# Modification Recommended Service Note

Supersedes:  
E5080B-23

## E5080B ENA Series Network Analyzer

Acoustic sound from PSU

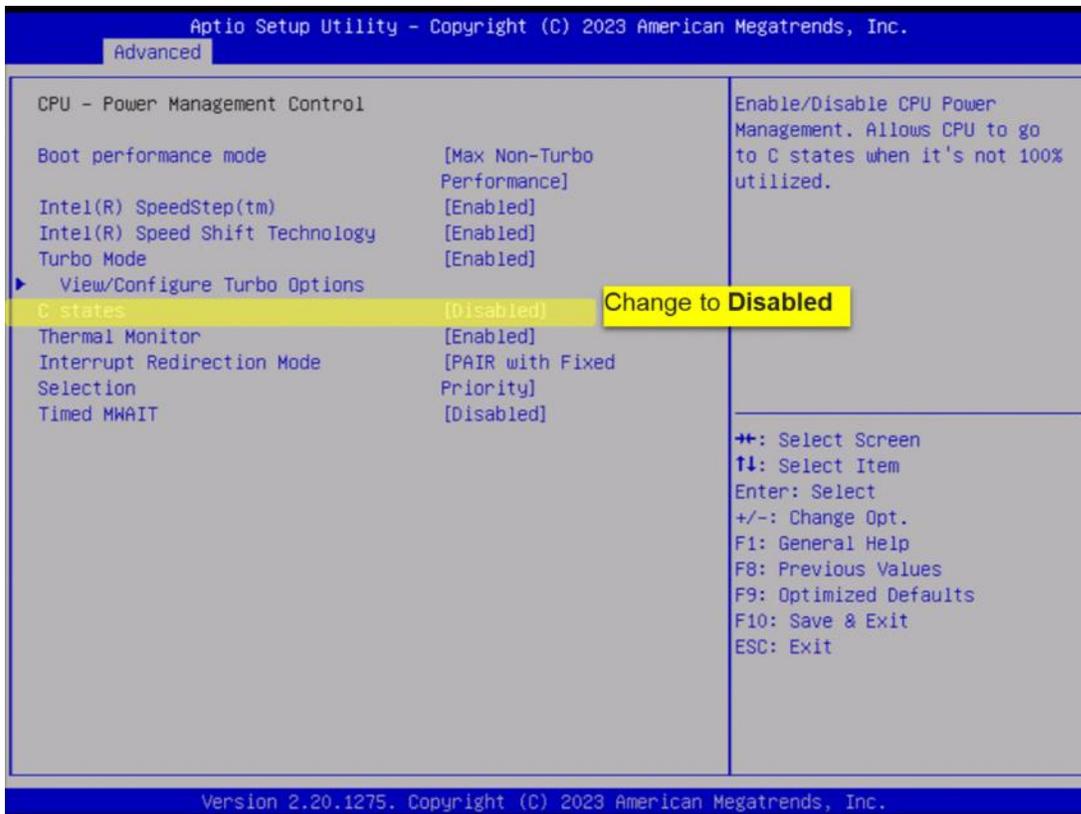
Solution 1: BIOS settings modification – Perform this first.

BIOS settings change will result in a lower acoustic sound level.

1. Connect a USB keyboard to E5080B.
2. Power on the ENA.
3. Press ESC/ DEL key repeatedly to enter BIOS setting page.
4. Select Advanced > Power & Performance > CPU – Power Management Control > C states > **Disabled**. Set the C states value from Enabled to Disabled.
5. Press ESC key twice
6. Select Save & Exit > Save Changes & Exit
7. Select Yes at Save Configuration & Exit?
8. Reboot the system.
9. Monitor if the acoustic/ tickling sound reduces to user acceptable level.

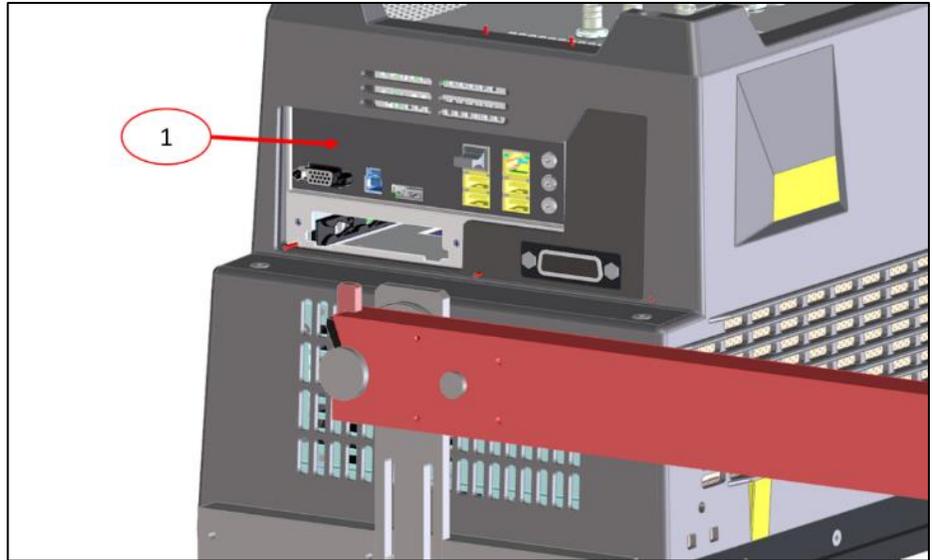
1.2 After the CPU module is installed, remember to replace the PCIO overlay as shown. The PCIO overlay cut-outs (X-Y position) for Gen2 CPU (MY593) are slightly shifted to fit Gen2 CPU and it is not 100% compatible with Gen1 CPU generation CPU. Replacement with Gen1 CPU PCIO overlay is required.

2. Power supply unit cable assembly replacement

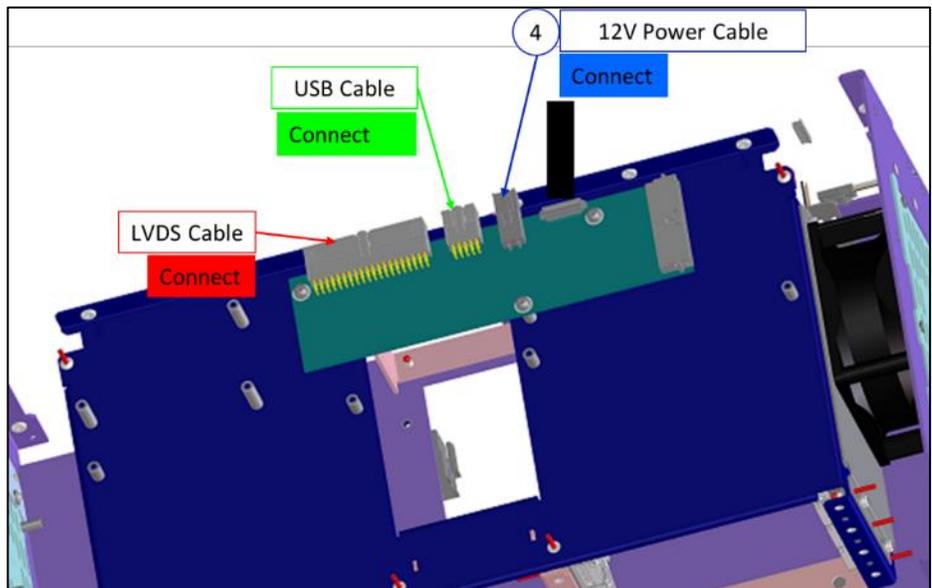
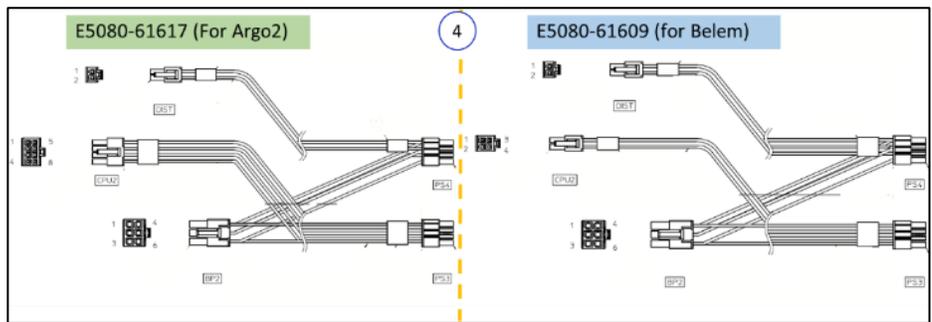
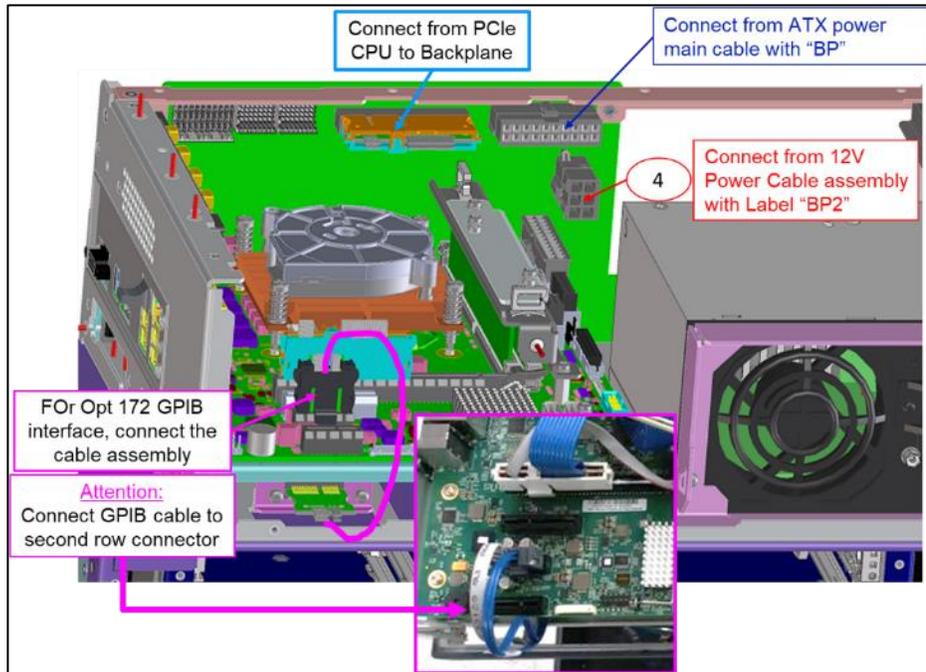
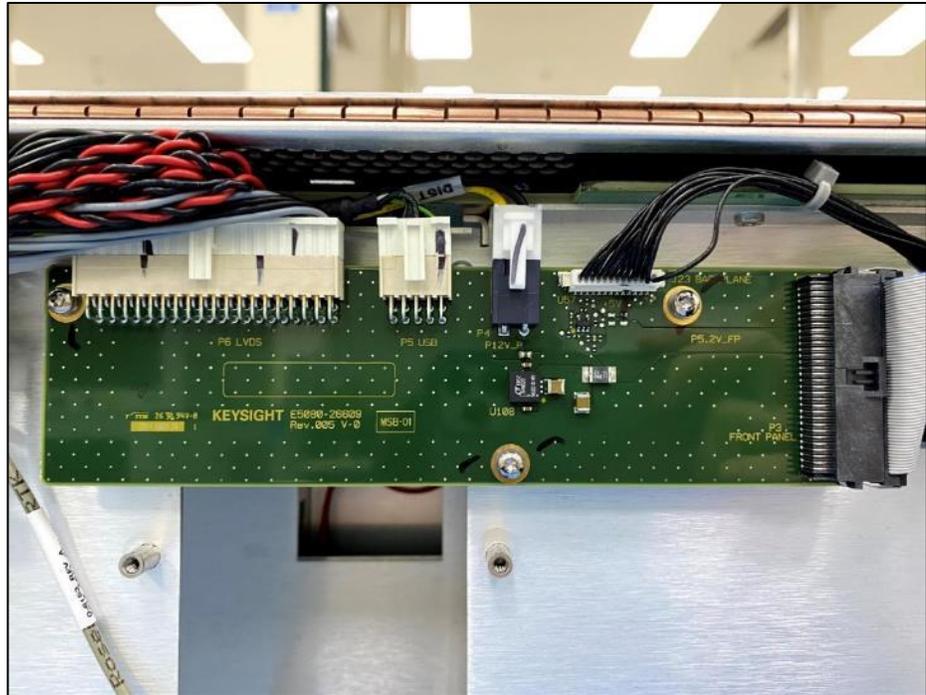
2.1 Shown is the comparison of the 12V power supply cable assembly.  
Perform the replacement as shown using E5080-61609.

### 3. Solid State Drive replacement

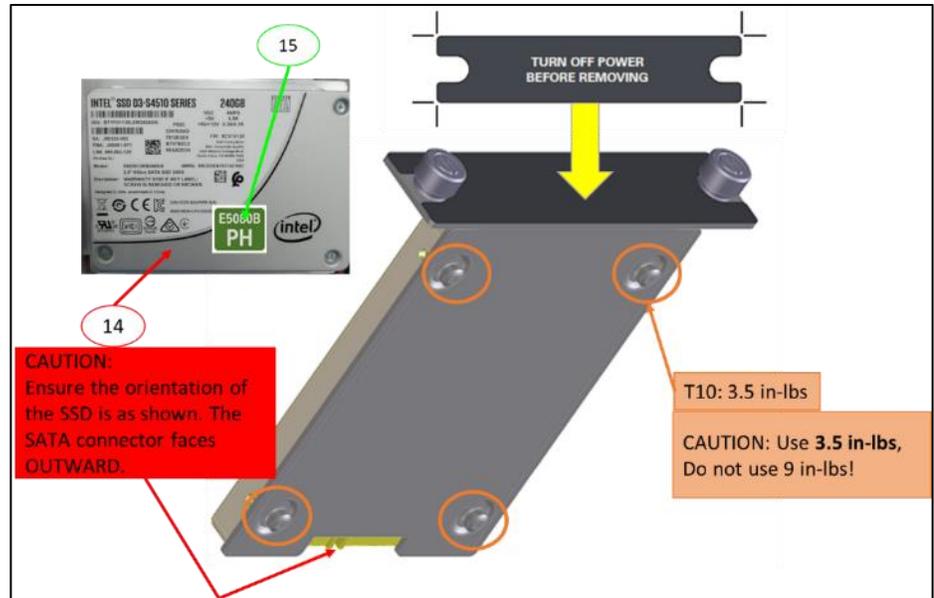
- 3.1 Replace the Gen2 CPU solid state drive (SSD) with SSD meant for Gen1 CPU. Reuse the removable SSD bracket and tray.
